LOT# 16E See Attached Extras SUTTON

Drywall stage - Inventory home  
updated: 09/3/2024

RN design Imagine • Inspire • Create TEL.(905)738-3177 FAX.(905)738-5449	MODEL	30-4	No.	ISSUED OR REVISION COMMENTS	DATE	DWN	CHK	SCALE	
	CLIENT	 Delpark HOMES	 CEDAR Ridge IN SUTTON	1.	ISSUED FOR CLIENT REVIEW	JUL. 12/13	KK	CR	3/16" = 1'0"

BASEMENT

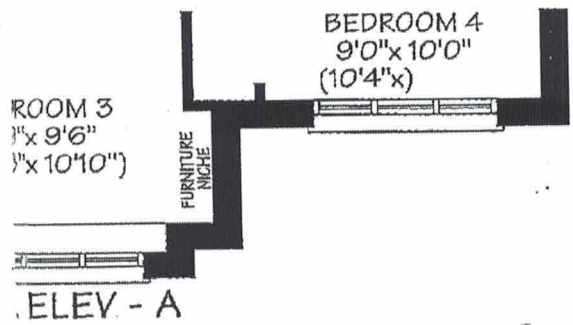
A/C unit

MAIN FLOOR

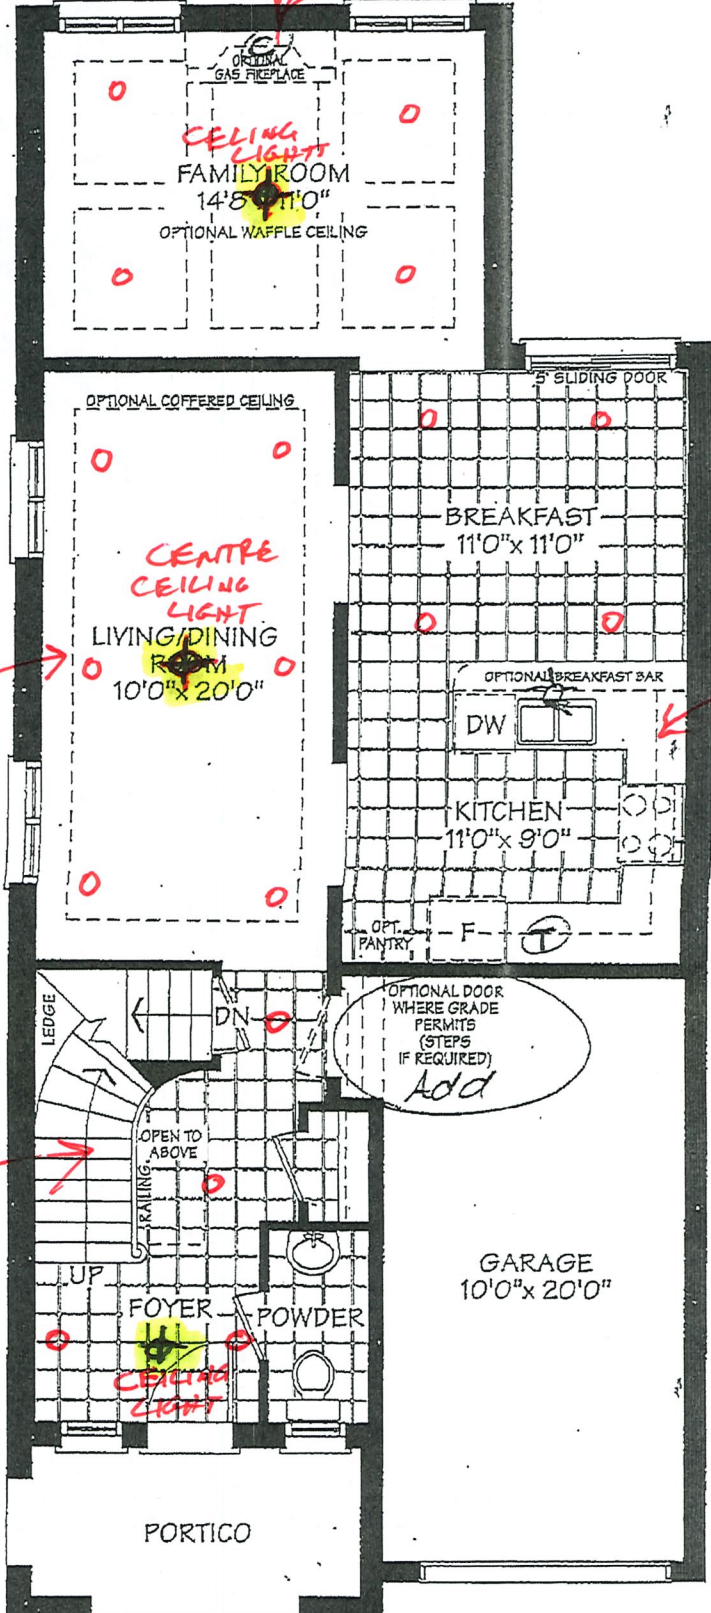
- - POTLIGHT
- 1ST FLOOR
- SMOOTH CEILINGS

ADD GAS FIREPLACE  
+ MANTLE

ADD  
COFFERED  
CEILING

36" UPPER  
CABINETS

ADD OAK  
STAIRS

R/I water line
